Building Manager: [Laura Tilley, laura.tilley@oregonstate.edu](mailto:laura.tilley@oregonstate.edu)  
 Assessment Date: 1/4/2022  
 Assessment Number: **10504**  
 Location: Snell Hall (MU East) Entire  
 Reinspection date:

A joint fire safety inspection of the facility listed above was performed by the Environmental Health & Safety - Fire and Life Safety and the Corvallis Fire Department. These fire safety deficiencies could result in a fire or jeopardize the safety of those occupying the facility. Please see that these items are corrected immediately and no later than the scheduled reinspection date noted with this report. If you have any questions regarding this inspection, please email Brian Lilley (EH&S - Fire and Life Safety) at [brian.lilley@oregonstate.edu](mailto:brian.lilley@oregonstate.edu).

Door Knobs

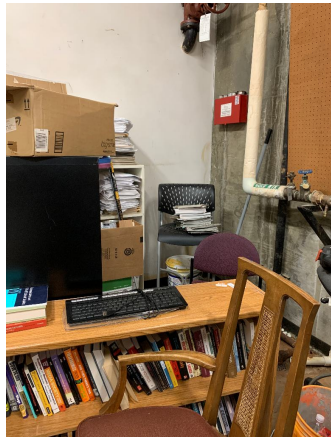
<b>Priority code</b>	<b>Standard in need of attention</b>	<b>Reg.Reference</b>	<b>Location</b>	<b>Resp</b>	<b>Observations &amp; Recommendations</b>	<b><a href="#">Date Corrected</a></b>
2	Door operating devices shall not require tight grasping, tight pinching or twisting of the wrist to operate.	2019 OFC 1010.1.9.1	Throughout:exit	FS	ALL doors leading out of building must be a lever-style handle and NOT a round knob.
